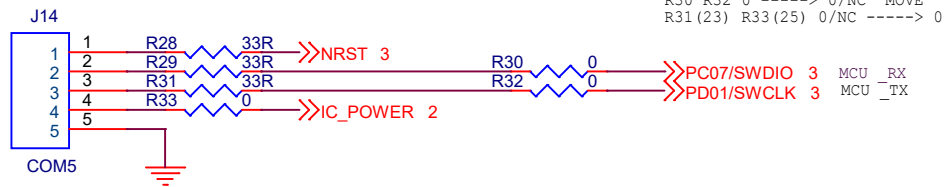
MODIFY (EN_010)
PA15 ----> PA03 MOVE
R30 R32 0 ----> 0/NC MOVE
R31(23) R33(25) 0/NC ----> 0
